File 1981-0095

Project Name: Western 6 Motel – Development in H.O.

Re: File 95-81 - Final Development Plan - Western Six Motel
Job # 813672

REVIEW SHEET SUMMARY

SHEET 1 of 6

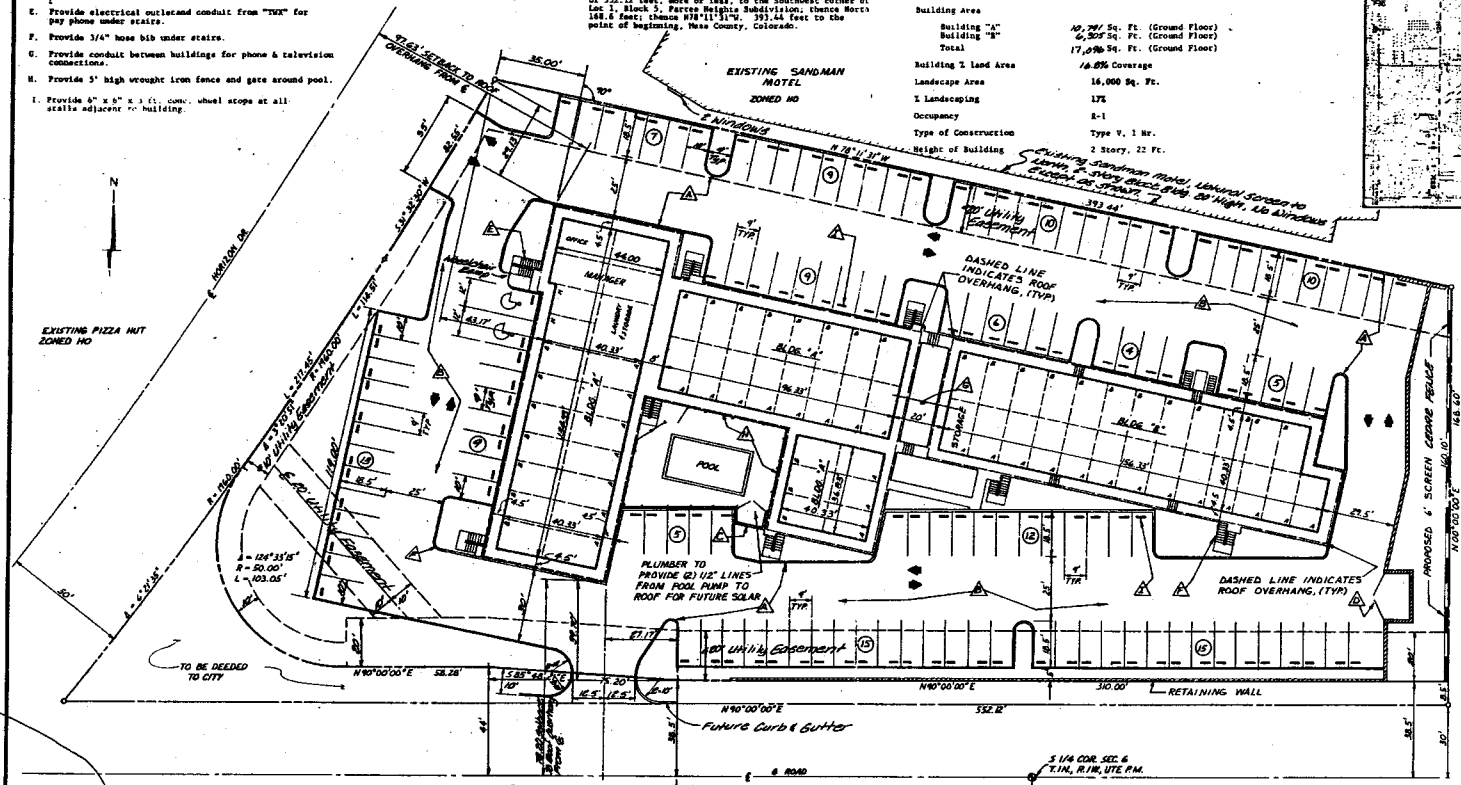
10/16/81	City Engineer Late <i>As per T.E. 3/8/82</i>	<p>What engineer prepared these plans? Access and parking configurations look reasonable. G Road half right-of-way <u>should be increased to 30 ft.</u> G Road and Horizon Drive intersection is not yet designed. We plan to construct Horizon Drive including that intersection in 1982. The 50 ft. radius at the corner indicated for right-of-way dedication is reasonable with what we know today. Power of attorney should be furnished for full street improvement on both Horizon Drive and G Road. It would be a lot better if the trash enclosure was located close to the G Road entrance so the large trucks wouldn't have to go through the parking lot. The "Grading and Drainage Plan" includes no quantification of flows.</p> <p>Almost the entire site will become hard surface so these flows should be quantified. (submit drainage calculations) How will the hillside seep be controlled? The grading and drainage plan should also show the existing storm drain pipes which have been installed on the site. The proposed "6 inch lateral" sanitary sewer system shown on their property is considered a sewer tap. The City will not be responsible for the 6 inch sewer system. I do suggest they consider cleanouts or manholes at all those sewer intersections and bends to help them not have maintenance problems.</p>

1. My review comments of October 15, 1981, are in error on one point. The 33 ft. half right-of-way specified for G Road is incorrect. G Road is to be designated as a minor arterial in the current Comprehensive Plan, Jim Bragdon and I agree with that designation. This portion of G Road is a designated bikeway on the adopted Bikeway Plan. Therefore, the minimum right-of-way needed will be 77 ft. as per the adopted standard resulting in 38½ ft. half right-of-way. The other review comments stand as written.

2. The proposed driveways shown on the October development submittal are acceptable as to location and size. We did note that the Grading and Drainage Plan shows the G Road driveway at the wrong location.

5. The right-of-way for G Road outlined above will not encroach on the proposed parking layout for the motel but it will put the street sidewalk immediately adjacent to the parking lot edge. The submitted Grading and Drainage Plan shows a retaining wall at the southeast corner of the site. It appears the wall will need to be extended westerly to at least the driveway entrance because of the elevation difference between G Road and the proposed motel parking lot.

<u>DATE REC.</u>	<u>AGENCY</u>	<u>COMMENTS</u>
12/3/81	G.J. Police Dept.	What types of locks will be provided for all rooms?
12/10/81	Transportation Engineer	I can appreciate the problems with the elevations along G Road, however, a single access point is not adequate to provide proper traffic circulation and emergency vehicle access to 130 rooms. Another problem with the single access point also exists - there is a possibility that Horizon Drive will have a raised median in this area which would eliminate left turns out of or into the Horizon Drive entrance. This would cause confusion and encourage U-turns.
12/11/81	City Fire Dept.	<p>We have met several times with the representative of this development and have worked out fire protection to our satisfaction. The 8 inch new line connecting to the Ute 18 inch in G Rd. and loop through property to the Ute 10 inch in Horizon Drive should provide adequate water.</p> <p>The three fire hydrants are required installed as to utility composit plan, sheet 3 of 6, 12/1/81, job number 813672.</p> <p>We would recommend that a second means of egress and access for emergency equipment be provided.</p>

12/15/81	Staff Comments	<p>How will landscaping be maintained? Low profile bushes at entry to parcel and what is the groundcover? What type of screening is provided on north side? Need something. Is there a ramp for Handi-capped parking? Is circulation ok per Fire Department for access? Need signage detail prior to Grand Junction Planning Commission public hearing for review What type of screen wall at east end of parcel? Is one access sufficient for 130 units? With lighting detail low level, directional so not to interfere with neighborhood, or adjacent property. Need copy of deed showing dedication of Right of Way prior to building permit. Street improvements to be coordinated with the City Engineer. An additional access on G Road should be provided to insure better circulation for fire and trash pick-up and service trucks. Project must obtain building permit within 1 year of final approval or be scheduled for a rehearing.</p>

1. Curb cut dimensions on Horizon Drive are shown on Site Plan. G Road entrance has been eliminated.
2. Trash pick-up has been coordinated with Bill Reeves of the Sanitation Department.
3. Structure setbacks are shown on the Site Plan.
4. Outdoor lighting is on the building roof by flood lights. Lighting is shown on Utility and Lighting Plan.

5. Handicap parking spaces will be designated with standard painted symbol. Handicap parking spaces are dimensioned on Site Plan.

12. Design of G Road and Horizon Drive has not been completed. City Engineer has indicated the amount of R.O.W. he needs for the design of these roads. The Site Plan shows the R.O.W. requested and will be deeded to the city.

The G Road R.O.W. has been discussed with the city engineer and the proposed R.O.W. shown on the Site Plan has been coordinated

<u>Agency</u>	<u>Response</u>
Grand Junction Police Dept.	Privacy - Individual keyed locks will be installed for each room and office. Dead bolts will be avoided if possible.
Transportation Engineer	After discussion with the Transportation Engineer, City Engineer and Planning Staff members on December 22, 1981 a common location of a second access along G Road was determined. Four units on the South end of the West building have been deleted to accommodate the access. The City Engineer determined that a grade break can begin 10' South of the North ROW line on G Road. Using this point a 9 to 10% grade was maintained down the access. This solution seems to be the most acceptable solution with maximum traffic circulation and access and minimum amount of construction and design cost.

All storm sewer pipe will be reinforced concrete pipe except the drain tile behind the retaining wall will remain PVC. Because of a high point at the access drive, an additional inlet will be installed and piped to the storm sewer along the South property line. This extra inlet will pick up drainage south of the buildings and East of the G Road Drive. Hydrology analysis will not be affected greatly because the drainage will go to the same location. Storm sewer construction plans and details will be submitted for approval as per city regulations prior to construction.

The retaining wall will be designed with provisions for height extension when G Road is improved. Another alternative is to work with the City and construct the entire wall to the height of proposed G Road in lieu of future assessments for G Road Improvements. The owner will work with the City of Grand Junction for an agreeable solution. Retaining wall construction plans and details will be submitted for approval prior to construction.

The Sandman Motel is approximately 5' North of the North parking lot and will act as a natural buffer. Building line is shown on the site plan. Since the parking lot has been put right on the North property line to allow maximum space along G Road, no screening area is allowed on the North side.

Eight copies of revised plan sheets 1 and 2 are submitted for your review. If more are required or additional information is needed, please call as soon as possible.

WESTERN HOTEL PROJECT
 WESTERN HOTEL
 SHEET 2 of 6

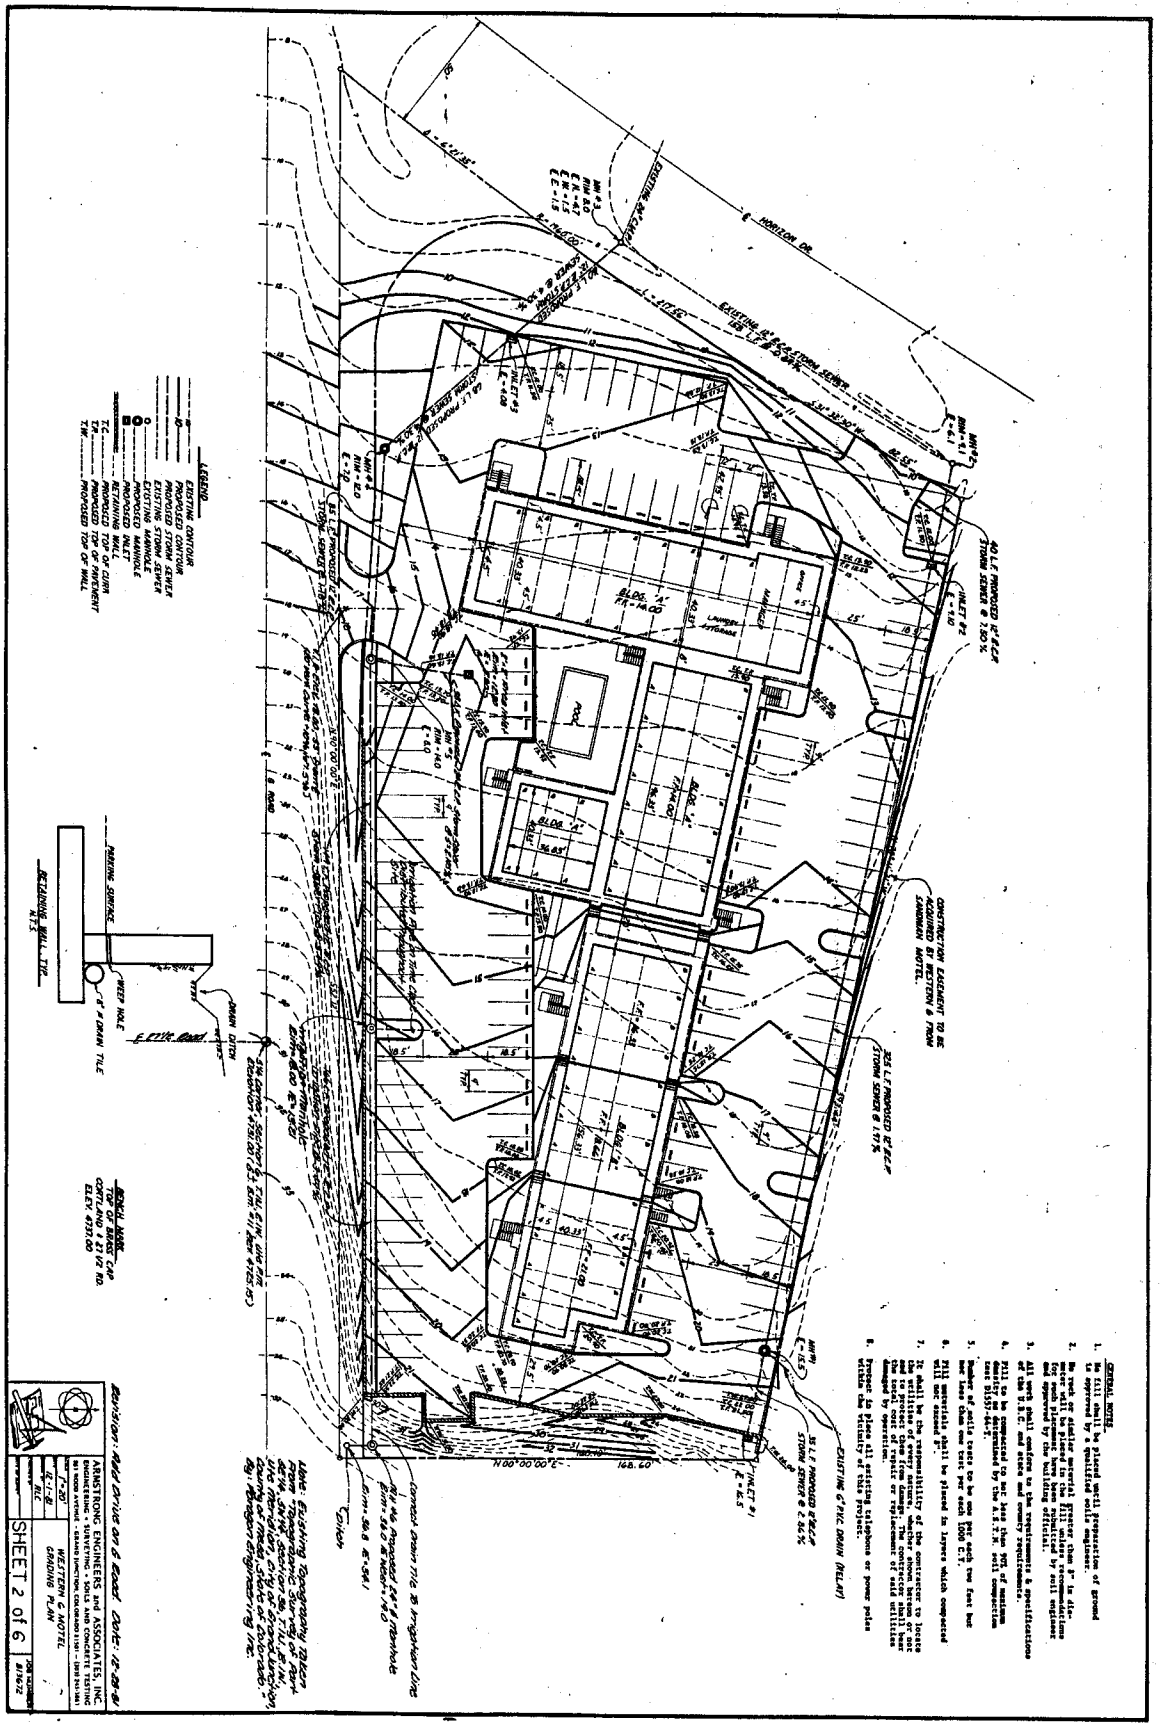
3. Standard concrete aprons as per Standard Drawing ST-1 will be provided as part of the Horizon Drive project at the driveway entrance locations shown on your plans. The on-site curbing should end at the back of apron. Please revise your drawings accordingly.

4. There appears to be a mistake concerning elevations shown on your plans for the existing storm sewer manholes in Horizon Drive. Our field survey data vs the elevations shown on your plan sheets follows:

<u>Location</u>	<u>City Survey</u>	<u>Armstrong Plans</u>
S $\frac{1}{4}$ Cor. Sec. 36	4725.23	4725.15
MH 3 Rim	4702.57	08.0
MH3 $\overline{\text{R}}$ North	4700.33	04.7
MH3 $\overline{\text{L}}$ West	4694.93	01.5
MH2 Rim	4703.50	09.1
MH2 $\overline{\text{L}}$	4700.50	06.1

As you can see, there appears to be a major "bust". You should research this matter and adjust plan elevations and proposed pipe profiles accordingly.

5. Plan sheet 2 shows reinforced concrete pipe and plan sheet 3 shows polyvinyl-chloride pipe for the storm sewers. As stated in planning commission review comments, PVC is not acceptable under paved areas.
6. As stated in planning commission review, 20 ft. wide easements should be provided along the storm sewers for the entire length of the property since these pipes will carry flows from the Partee Heights neighborhood to the east.
7. Add the following note to plan sheets 2 and 3:

4. The driveway entrance to G Road is still shown incorrectly on the plans. The concrete drive apron will be constructed by the City as part of the G Road improvements and will be in accordance with Standard ST-1. Plans sent to you on May 18, 1982, will govern the grades. The centerline of the G Road driveway has back of apron at approximately 40 ft. from centerline of G Road and at elevation 4713.19. The grade from lip of gutter to back of apron is 6%.
